5. Design changes, EIS clarifications and additional information

5.1 Design changes

NORTHERN SYDNEY FREIGHT CORRIDOR

EPPING TO THORNLEIGH

--	---	---	--	--	--	--	--------------	---

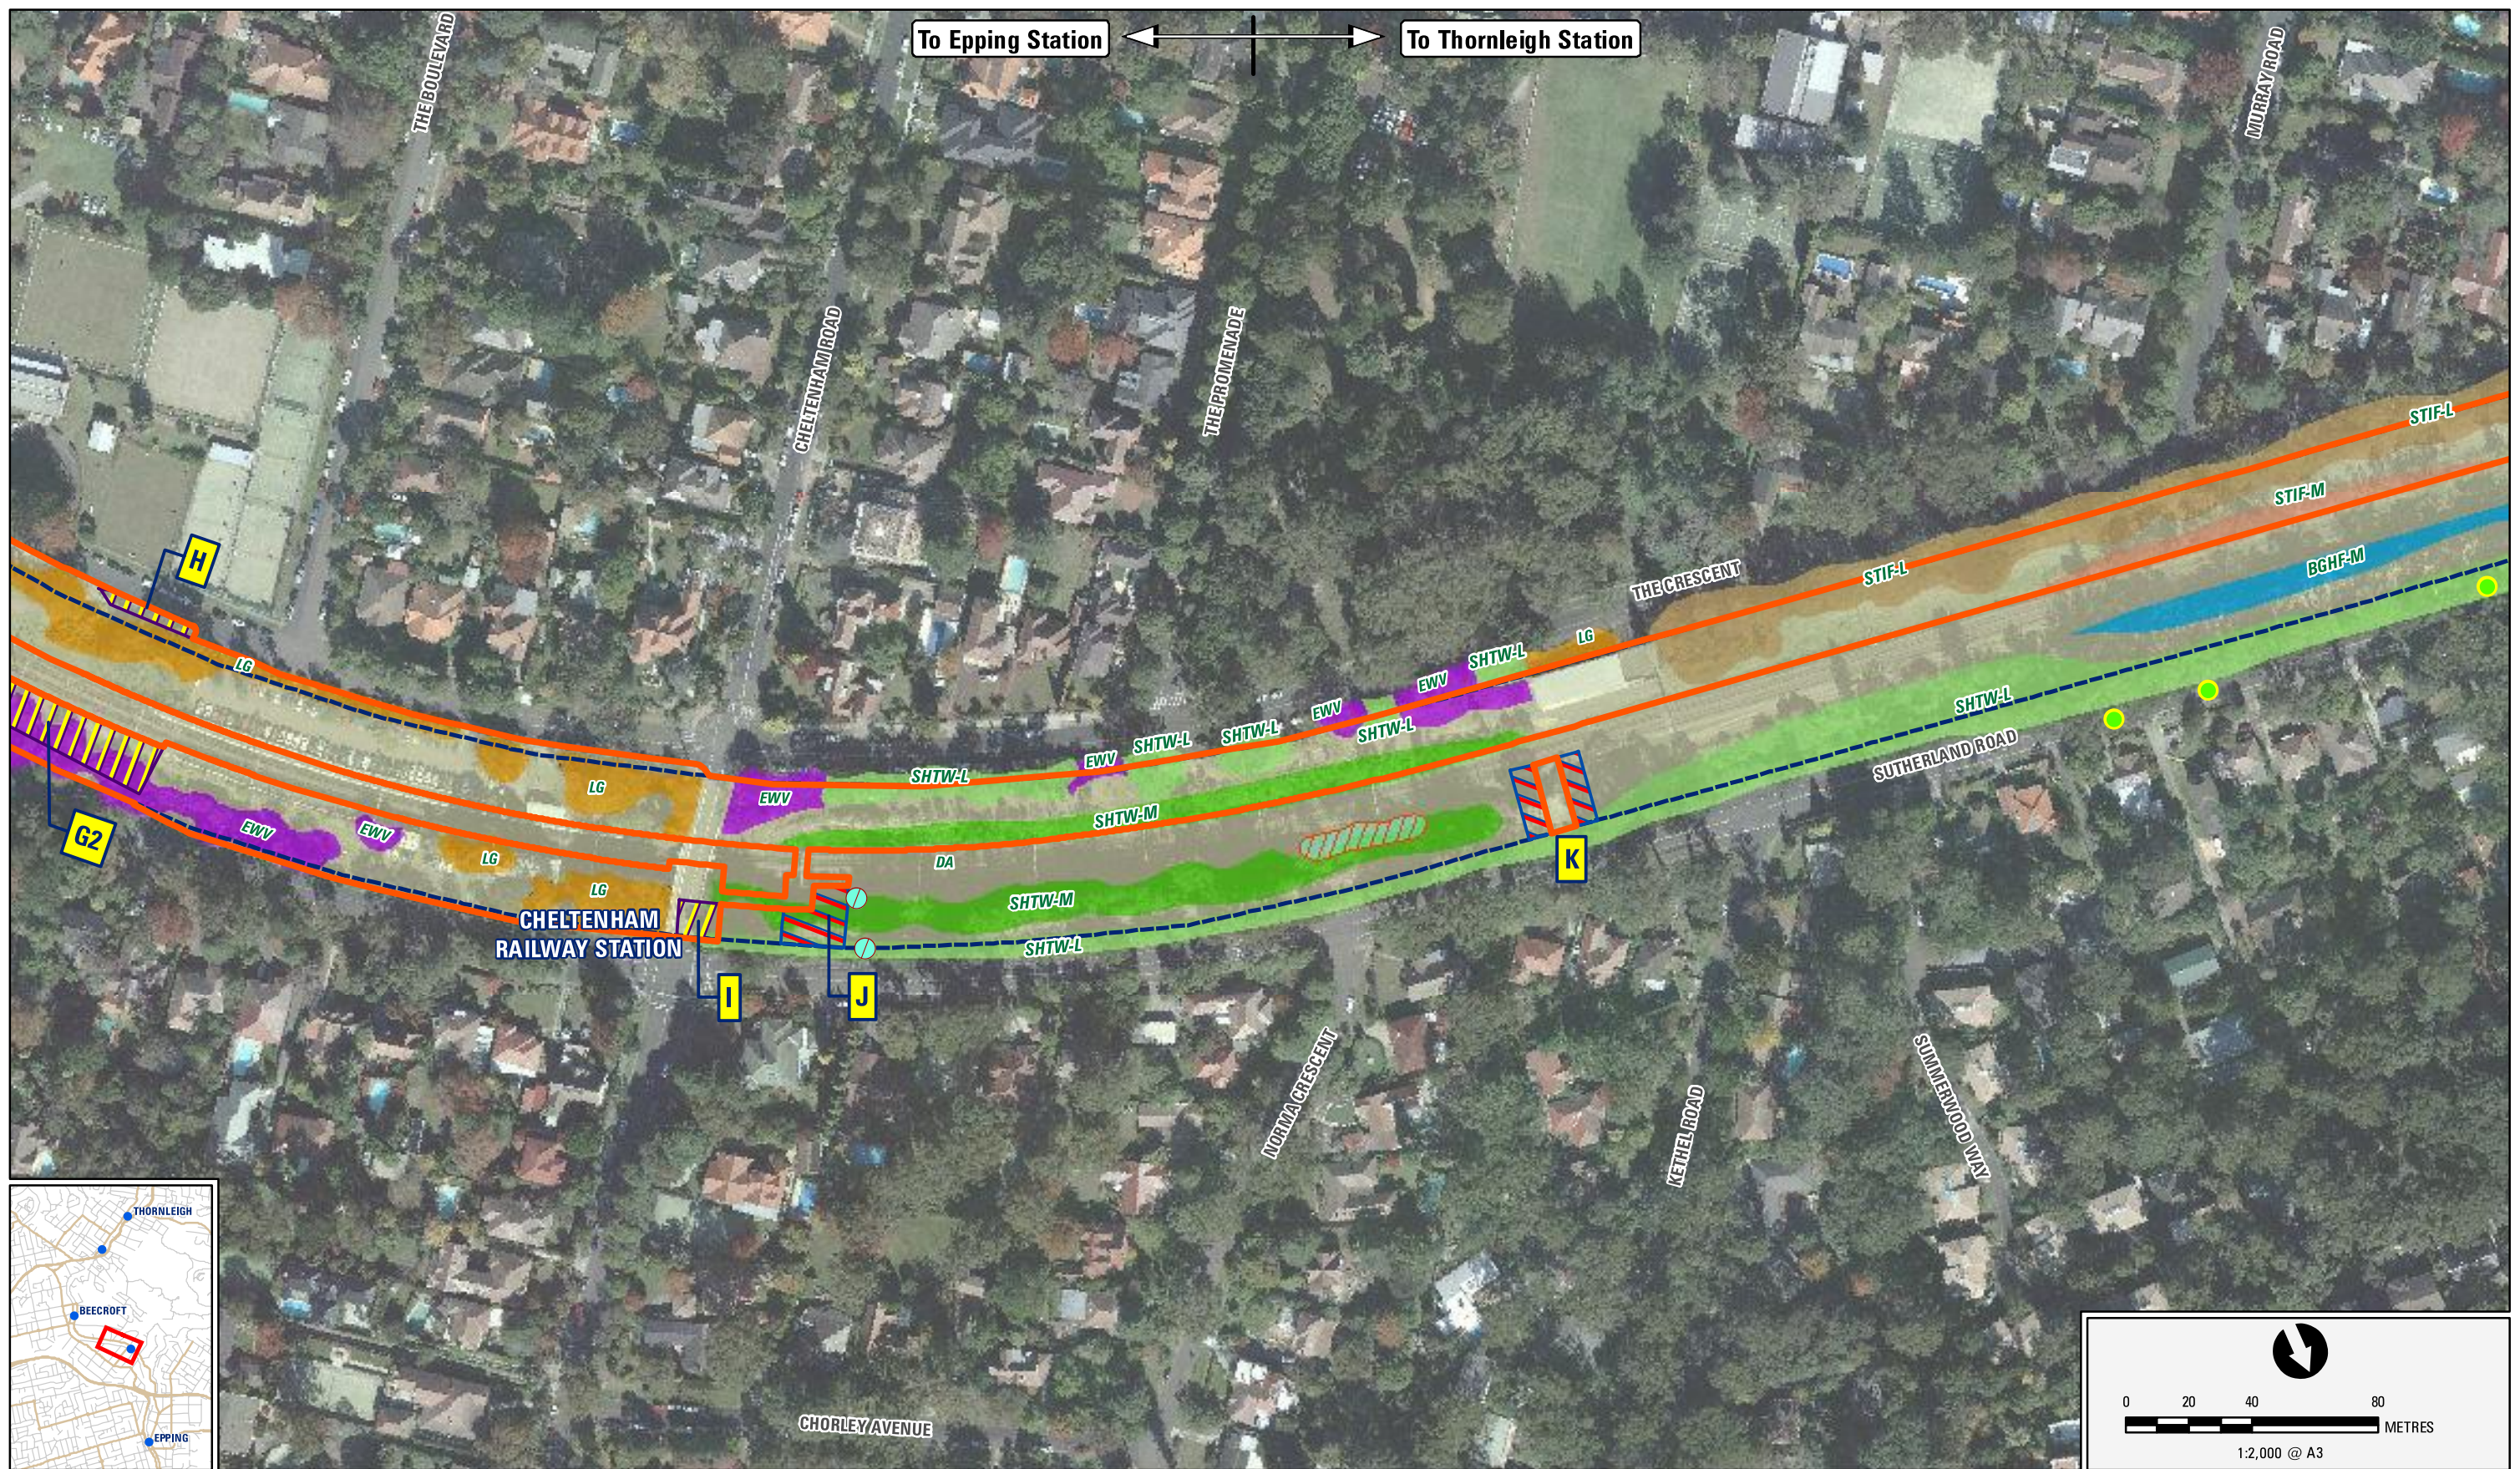
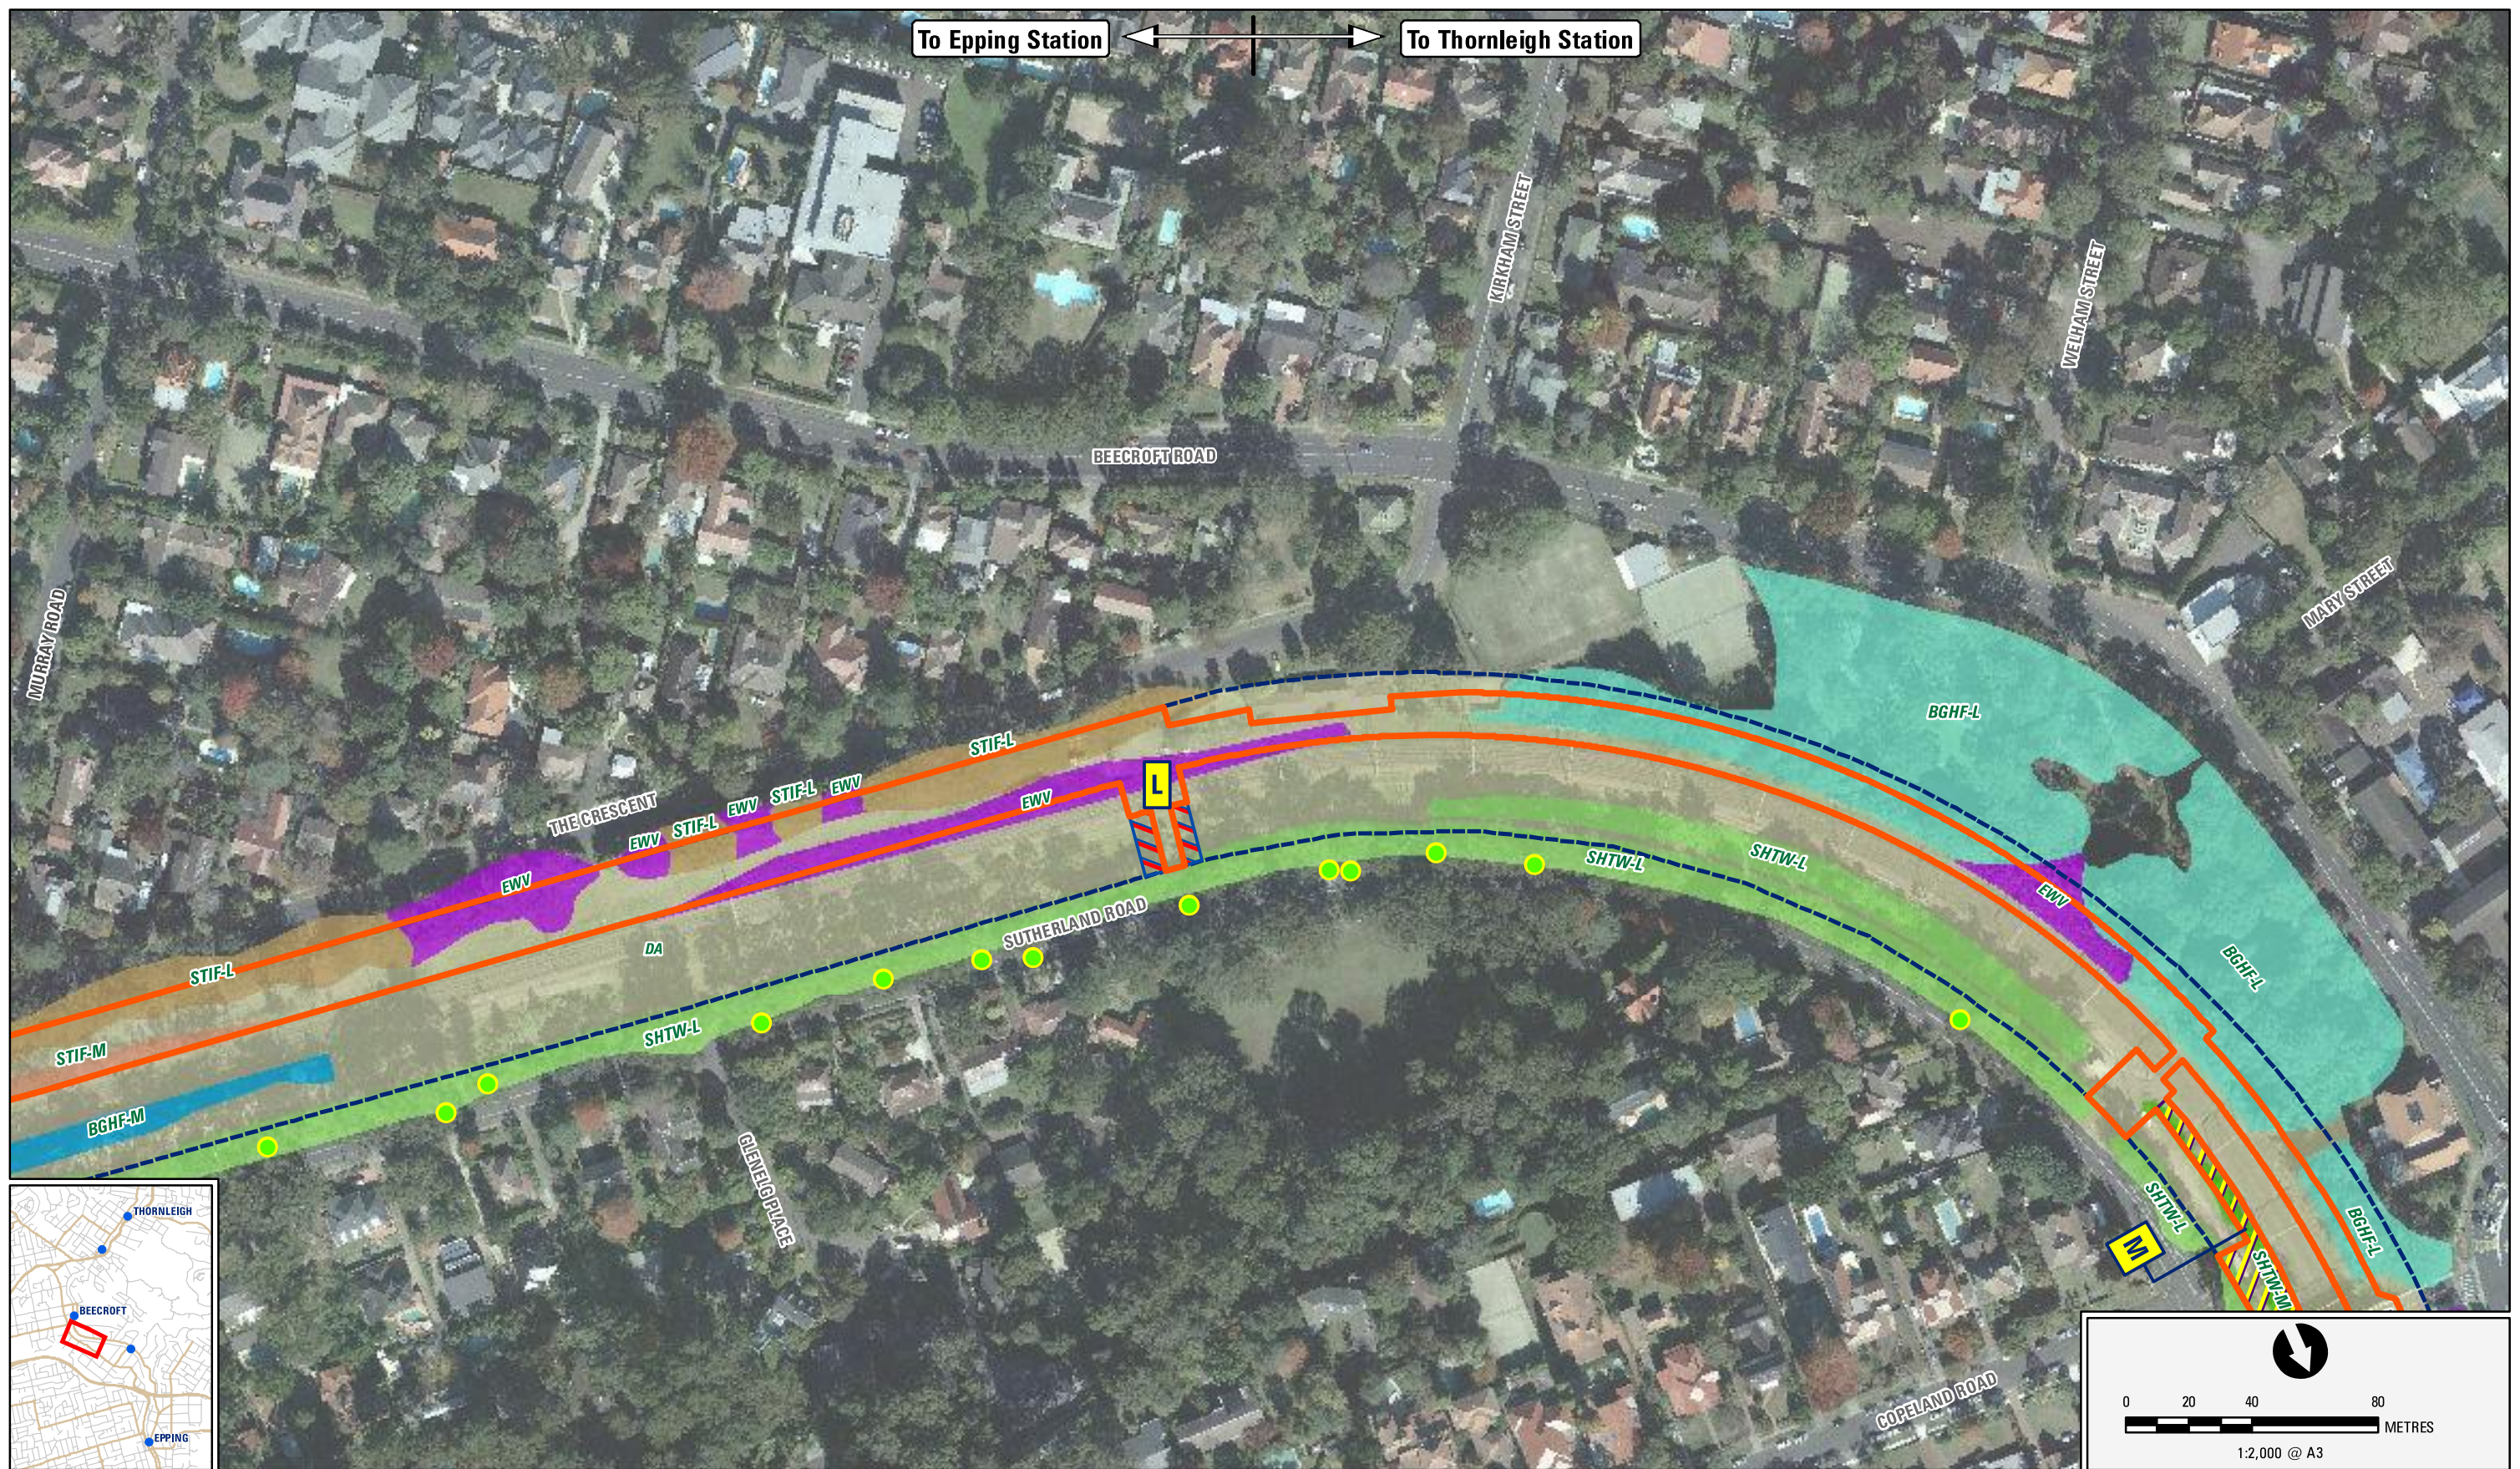
The construction impact area for the ETTT proposal, as shown in Figure 5.2 of the EIS, has been amended in various locations based on a review of constructability requirements. An outline of the proposed changes in construction impact area is provided in Table 5.1. A summary of the potential change in impact of the ETTT proposal as a result of each change is also provided in Table 5.1. The revised construction impact area for the ETTT proposal is shown in Figure 5.1.

Changed impact area	Description of proposed change	Summary of potential impacts
A	General work area increase to allow for the connection of the proposed railway services to existing facilities.	Increase in vegetation clearing and associated visual amenity impacts.
B1 and B2	Work area increased (onto Government owned land) to provide sufficient space for construction works, including the construction of the proposed viaduct and rail bridge crossing over the M2 Motorway and the delivery/storage of construction materials.	Increase in vegetation clearing and associated visual amenity impacts. Potential minor impact to heritage listed 'Bushland – Road reserve (between Carlingford Rd and Kandy Avenue)' (Hornsby LEP I 357) as a result of B1. Potential impact to the convict-built stone causeway crossing Devlins Creek (listed on Hornsby LEP) as a result of B2.
C1 and C2	General work area increase to provide additional area for access and construction of the proposed rail bridge crossing over the M2 Motorway.	Increase in vegetation clearing and associated visual amenity impacts. Potential impact to the convict-built stone causeway crossing Devlins Creek (listed on Hornsby LEP) as a result of C1.

D	Increase in trenching or installation of galvanised steel troughing for the connection of railway services between areas north and south of the M2 Motorway.	Increase in vegetation clearing and associated visual amenity impacts.

Changed impact area	Description of proposed change	Summary of potential impacts
E	Widened impact area to facilitate the establishment of a general work area. Area required for additional laydown, materials storage, construction of cuttings, establishment of a haul road for the removal of spoil, as well as to provide access for launching the structure of the proposed rail bridge crossing over the M2 Motorway.	Increase in vegetation clearing and associated visual amenity impacts. Area located adjacent to 'Ashby', a heritage listed house at 94 The Crescent, Cheltenham (Hornsby LEP I 297). Potential reduction in screening vegetation along the road reserve.
F	Modification to the combined services route (CSR).	Increase in vegetation clearing.
G1 and G2	General works area increase for a new power room, radio antenna and equipment room, and backup power supply.	Increase in vegetation clearing and associated visual amenity impacts.

H	Impact area widened to property boundary.	Nil.
I	General works area increase to facilitate construction of a new railway services pit and connection with public utilities/services.	Increase in vegetation clearing and associated visual amenity impacts.
J	Reduction in impact area due to the review of constructability requirements.	Reduction in vegetation clearing and associated visual amenity impacts.
K	Reduction in impact area due to the reduced clearance required at construction access gates.	Reduction in vegetation clearing and associated visual amenity impacts.
L	Reduction in impact area due to the reduced clearance required at construction access gates.	Reduction in vegetation clearing and associated visual amenity impacts.
M	General works area increase to facilitate construction of a new railway services pit and connection with public utilities/services.	Increase in vegetation clearing and associated visual amenity impacts.

O	Reduced area to reduce impacts on Beecroft Station Gardens and playground.	Reduction in vegetation clearing and associated visual amenity impacts.
P	Optimised car parking area to reduce impact area without reducing the number of car parking spaces to be provided.	Reduction in vegetation clearing and associated visual amenity impacts.
N	General works area increase to facilitate construction of a new railway services pit and connection with utilities.	Increase in vegetation clearing and associated visual amenity impacts.
Q	Increased construction impact area for the establishment of the combined services route and pits. Increase in trenching for services to facilitate construction of new pits and connections to railway services.	Increase in vegetation clearing and associated visual amenity impacts. However, impacts would be mostly confined to existing access roads within the rail corridor.
R	Increase in construction impact area due to a refinement of the new high voltage cable route	Increase in vegetation clearing and associated visual amenity impacts.

S	General works area increase to facilitate construction of additional services as well as facilitating construction access from Hampden Road, if required.	Increase in vegetation clearing and associated visual amenity impacts. However, impacts would be mostly confined to existing access roads within the rail corridor.
T	General works area increase for the installation of additional railway services.	Increase in vegetation clearing and visual amenity impacts
U, V and W	Reduction in impact area due to the reduced clearance required at construction access gates.	Reduction in vegetation clearing and associated visual amenity impacts.
